**Notification#20240628014.0
Device symbolization update for Select Devices
Information Only**

Date: June 29, 2024
To: PREMIER FARNELL PCN

Notification Number:	20240628014.0	Notification Date:	June 29, 2024
Title:	Device symbolization update for select Devices		
Customer Contact:	Change Management team	Dept:	Quality Services
Change Type:			
<input type="checkbox"/>	Assembly Site	<input type="checkbox"/>	Design
<input type="checkbox"/>	Assembly Process	<input type="checkbox"/>	Data Sheet
<input type="checkbox"/>	Assembly Materials	<input type="checkbox"/>	Part number change
<input type="checkbox"/>	Mechanical Specification	<input type="checkbox"/>	Test Site
<input checked="" type="checkbox"/>	Packing/Shipping/Labeling	<input type="checkbox"/>	Test Process
<input type="checkbox"/>		<input type="checkbox"/>	Wafer Bump Material
<input type="checkbox"/>		<input type="checkbox"/>	Wafer Bump Process
<input type="checkbox"/>		<input type="checkbox"/>	Wafer Fab Site
<input type="checkbox"/>		<input type="checkbox"/>	Wafer Fab Materials
<input type="checkbox"/>		<input type="checkbox"/>	Wafer Fab Process

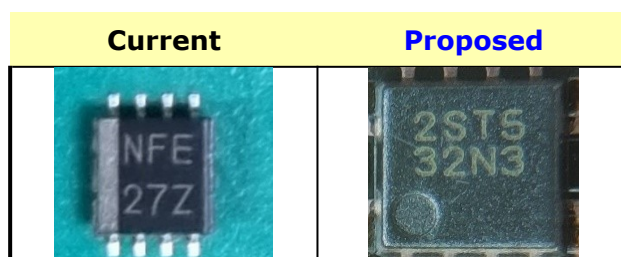
Texas Instruments Incorporated is announcing an update to the device symbolization for the devices shown below (pin one stripe to dot and 3 to 4 character) below as follows:

Device marking change only
